(This Service Letter Is FAA Approved)

SUBJECT: Installation of Hanlon & Wilson Exhaust System

MODELS AFFECTED: M-21 (M-20B), Serial Numbers 1701 thru 1939

This Service Letter reidentified as
Service Bulletin M-20-86
per Service Instruction M20-15.

FIGURE 1

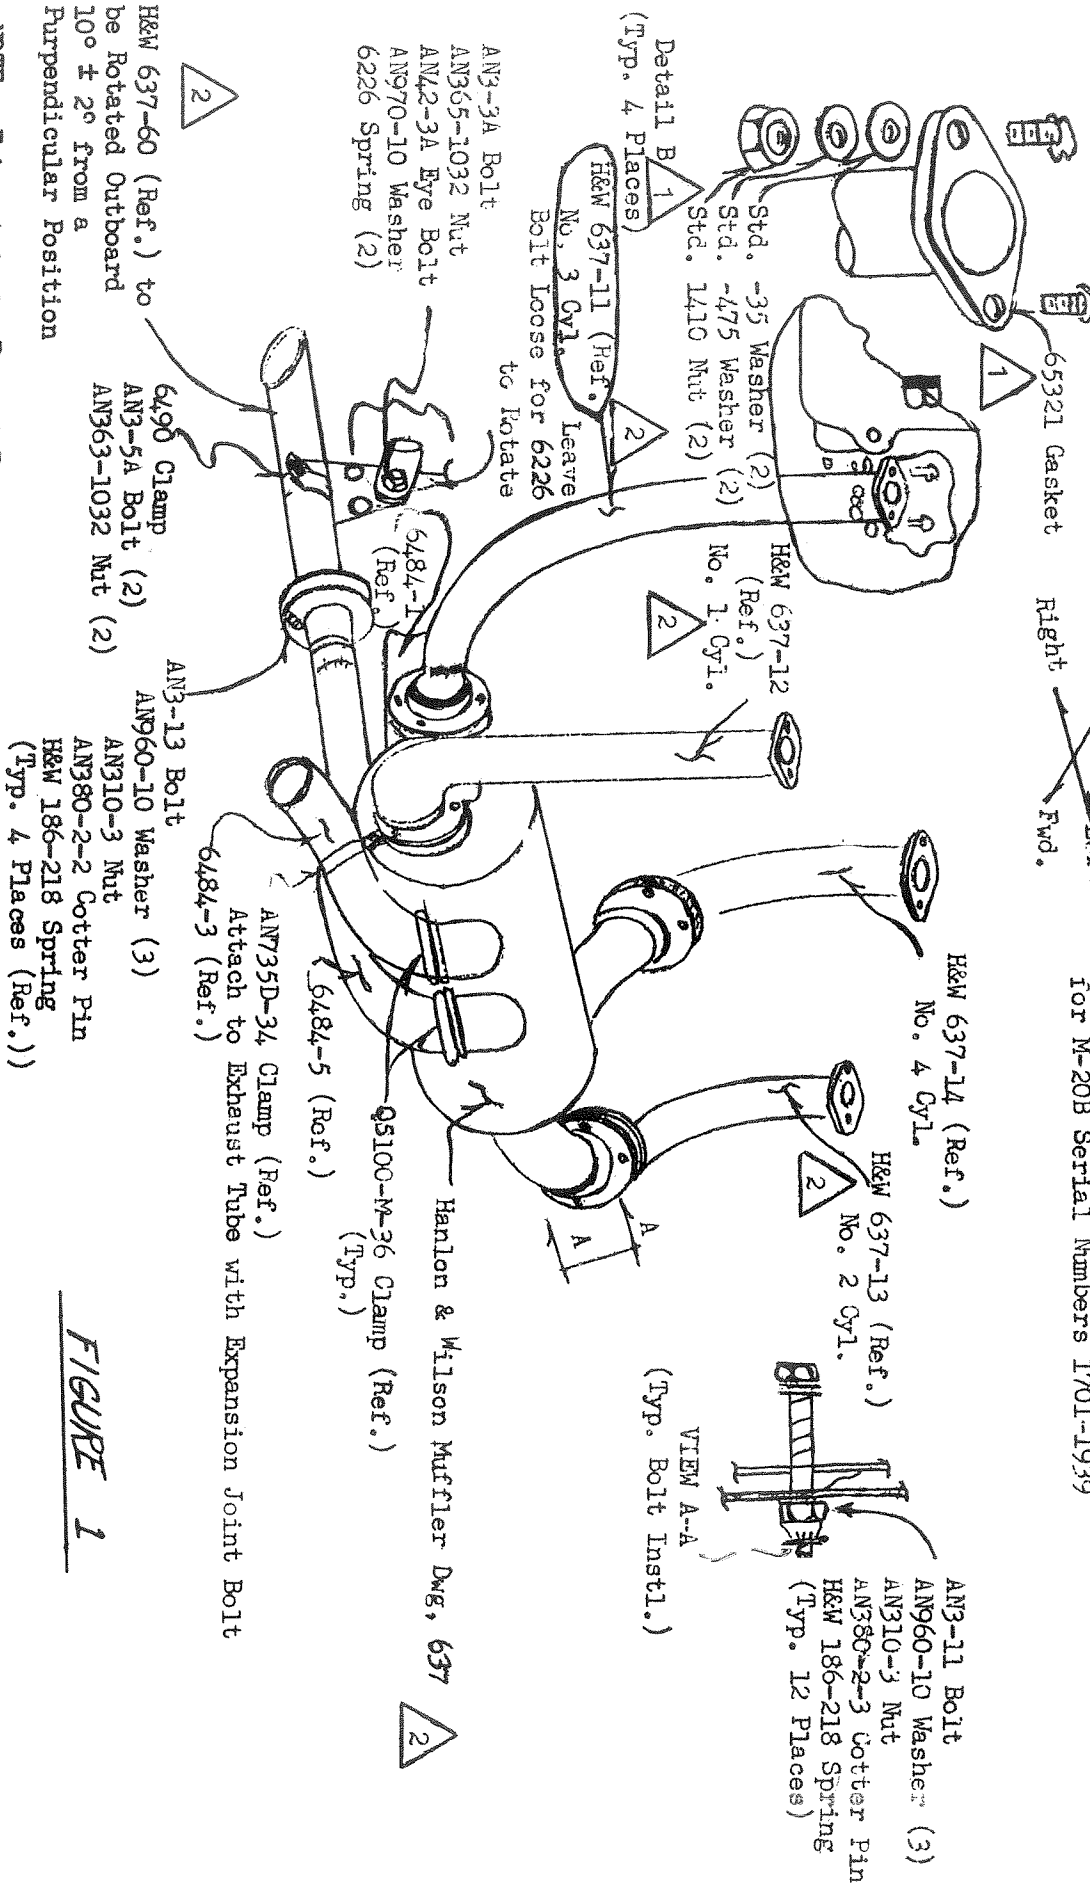
- c. Hanlon & Wilson No. 637-11, -12, -13, & -14 exhaust extensions on cylinders as shown in Figure 1, Detail B. Leave the nuts attaching extensions very loose at this time.

- d. Install exhaust extensions on muffler assembly as shown in Figure 1, View A-A. Nuts should be installed on the bolts only far enough so that the cotter pins may be installed. DO NOT TIGHTEN THE NUTS.

- f. Install Hanlon & Wilson No. 637-60 tail pipe as shown in Figure 1.
 - g. Attach 6484-5 duct to heater and 6504-1 elbow. Rotate elbow on carburetor air box to obtain 1/8" to 1/2" clearance between 6484-5 and 6179 air intake duct. Tighten clamp and install screw to secure P/N 6504-1 elbow.

FIGURE 2

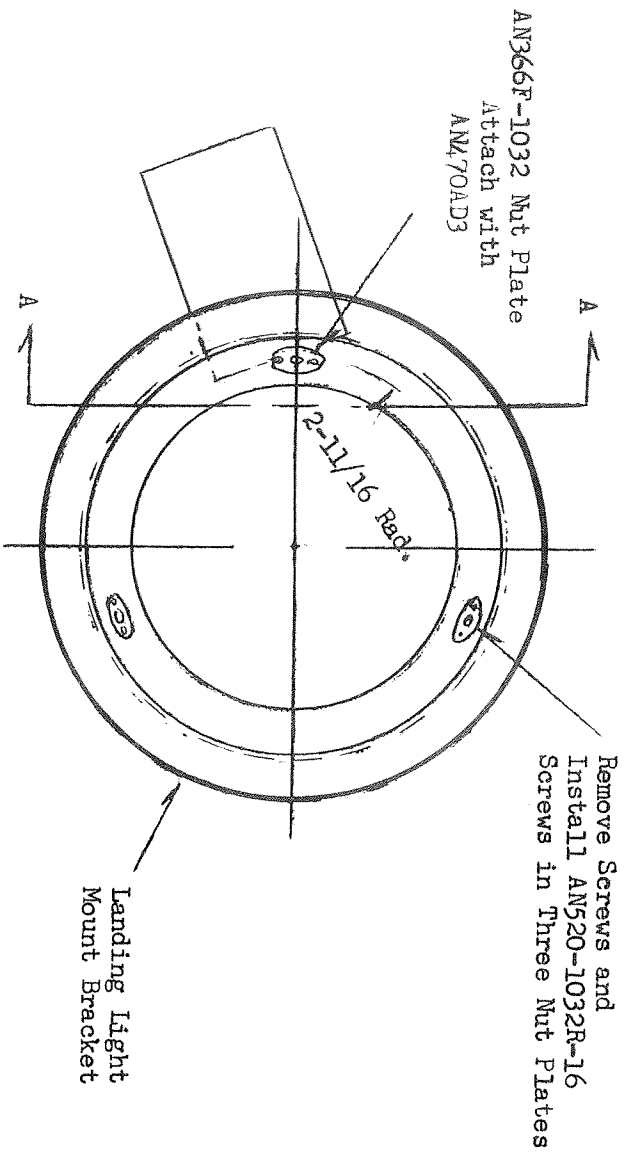
3. Rework the cabin heat valve as shown in Figure 2, Detail C.
4. Rework the landing light bracket as shown in Figure 3.
5. Install the following equipment in the sequence listed below:

- a. Install P/N 6504-1 on carburetor air box as shown in Figure 2, Detail B. DO NOT tighten clamp or install screw at this time.
 - b. Install Hanlon & Wilson No. 637 Muffler Assembly.

- h. Install P/N 6467 alternate air source tube as shown in Figure 2, View A-A.
 - i. Re-install P/N 6060 cowl brace at firewall attachment.
 - j. Install P/N 6484-1 & -3 ducts as shown in Figure 2.

FIGURE 3

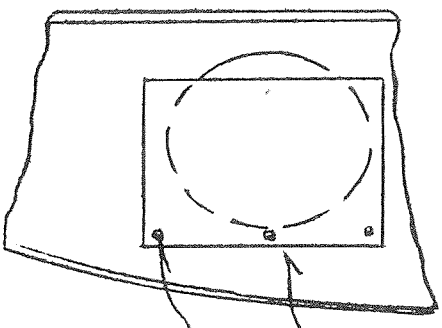
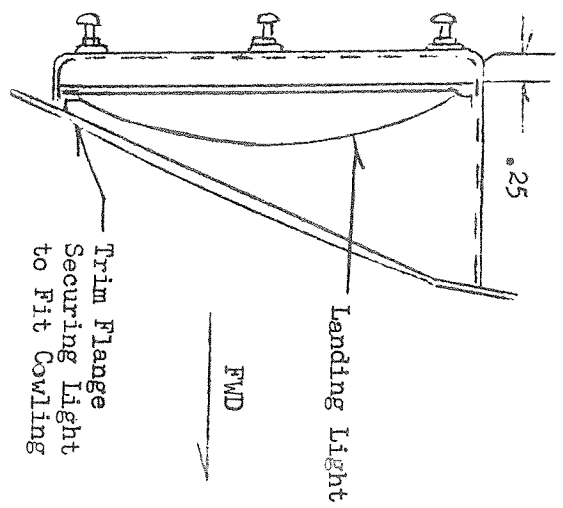
- k. Seal the original alternate air source inlet on the landing light bracket as shown in Figure 3, View A-A.
 - l. Install landing light as shown in Figure 3.
